Access Compliance Report

Public Rights-of-Way

(Curb Ramps)

Intersection ID: 3569	Main Street: OLYMPUS_DR	Cross Street: SHIMMERING LAKE_DR	Location: NW
ADA ID: 600D3A023CDC	Ramp Type: Perp	Initial Pass/Fail: Fail	Overall Compliance: No
Severity Score: 22.5			
Codes/Mitigation Info/Possible Solution		Field Measurements/Component Compliance

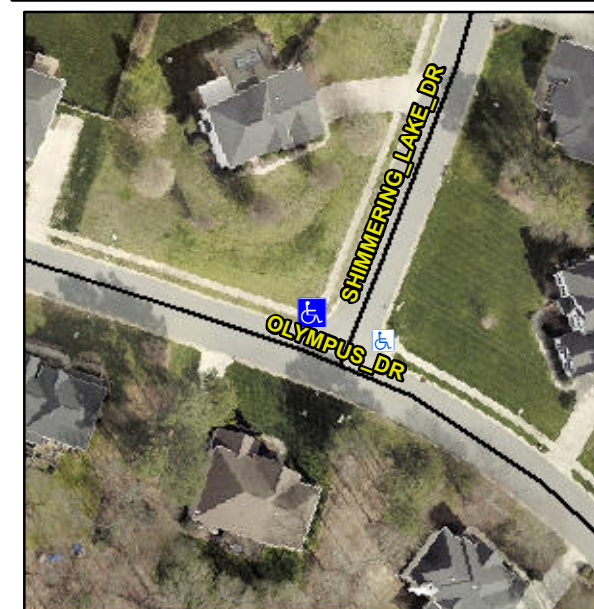
R304.5.1, R304.2.2, R304.5.3

Compliance	Description	Data	Compliance	Description	Data
N/A	Ramp Length (in)	44.0	No	Ramp Slope (%)	10.0
No	Ramp Width (in)	36.0	No	Ramp XSlope (%)	3.5
N/A	Flare Type LT	N/A	N/A	Flare Type RT	N/A
N/A	Flare Slope LT (%)	N/A	N/A	Flare Slope RT (%)	N/A
N/A	Flare Traversable LT?	N/A	N/A	Flare Traversable RT?	N/A
N/A	Landing Length (in)	N/A	N/A	DWS Provided?	N/A
N/A	Landing Width (in)	N/A	N/A	DWS Contrast?	N/A
N/A	Landing Slope (%)	N/A	N/A	DWS Length (in)	N/A
N/A	Landing X Slope (%)	N/A	N/A	DWS Full Width?	N/A
N/A	Landing Curb? (Y/N)	N/A	N/A	DWS Offset (in)	N/A
N/A	Shared Landing?	N/A			
N/A	Gutter Ponding?	N/A	N/A	Gutter Slope (%)	N/A
N/A	Gutter Lip Ht (in)	N/A	N/A	Gutter X Slope (%)	N/A
N/A	Painted X Walk1?	No	N/A	Painted X Walk2?	N/A
	X Walk 1 Direction	To SE		X Walk 2 Direction	N/A
N/A	X Walk 1 Width (in)	N/A	N/A	X Walk 2 Width (in)	N/A
	X Walk 1 Slope (%)	1.8		X Walk 2 Slope (%)	N/A
	X Walk 1 X Slope (%)	3.7		X Walk 2 X Slope (%)	N/A

Remove & Replace Entire Ramp.
